Product Change Notification

Product Change Notification: PCN-21-121539

DEUTSCH Size 16 S&F pin terminal Gap Change.

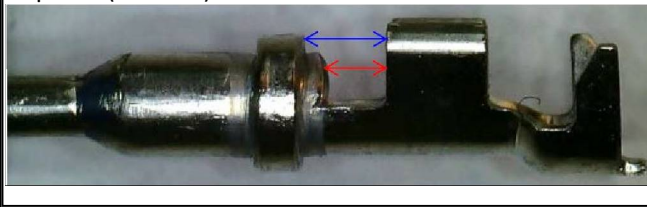
DEUTSCH Size 16 S&F pin terminal Gap Change. The Industrial and Commercial Transportation business unit of TE Connectivity is making a change to the gap between the locking shoulder and wire crimp barrel for the part number(s) listed below. NOTE: The distance from the locking shoulder to the wire crimp barrel has not changed nor the overall length of the terminal. These PNs are TE proprietary designs, therefore considered catalog/general market product. PPAP and/or sample requests must be submitted within 14 days of PCN submission via ict-ppap-request@te.com or ePPAP system. Submission will not occur without request. If PPAP requested, disposition response is required within 14 days of submit date or it will be considered approved. The change does not impact performance and crimp application tooling. Product drawing(s) are affected. REASON FOR CHANGE: The change is necessary to align the design with other size 16 S&F pin terminals. IMPORTANT: The current and previous revisions of these parts can be used interchangeably in the field. The change(s) are being phased in gradually and previous revision can remain stocked until use. Shipments of both configurations may be mixed.

Gap Size (BEFORE)

Gap Size (AFTER)
